| **Subject:** | RE: Tract 50666 |

*TRACT 50666*

**PVDS INTERSECTION EXHIBIT**

**PALOS VERDES DRIVE SOUTH & COSTA DE LA ISLAS**
**WITH NO RIGHT TURN TO DEVELOPMENT**

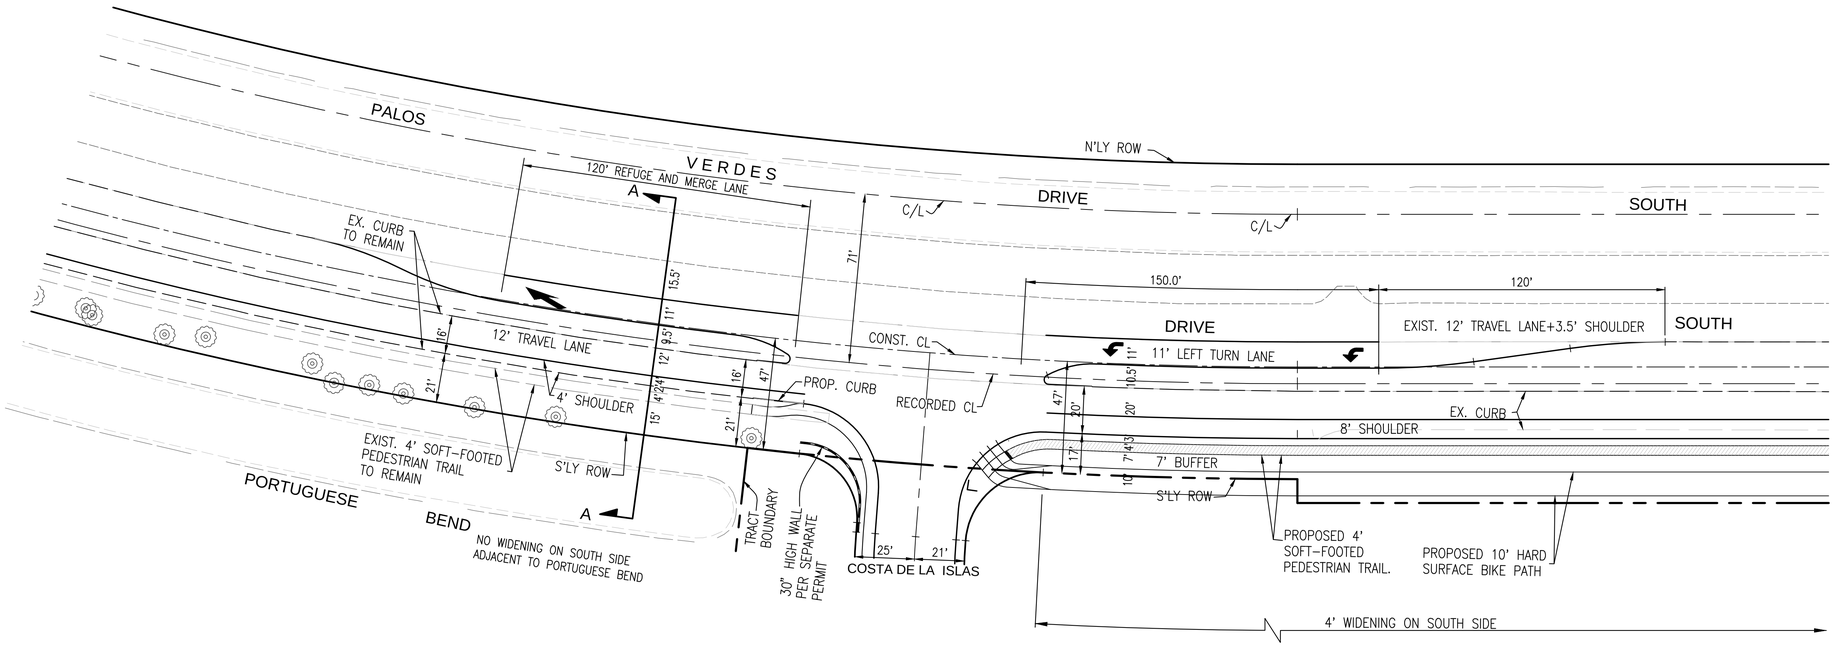
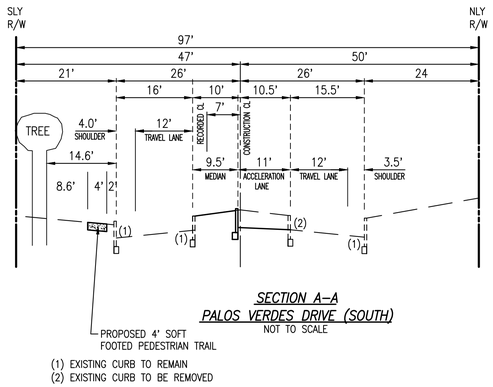
1-we would like the 10' wide Hard Surface Bike Path to be of concrete.
2-Please indicate where this bike path goes to and if terminates where and how?
3-Pls show a cross section across PVDS to the east of Costa De La Islas.
4-Please extend the 30-inch wall to capture the light beams from the vehicular traffic turning onto Costa De La Islas
5-Please show the type of proposed landscaping within 3' and 7' buffer.
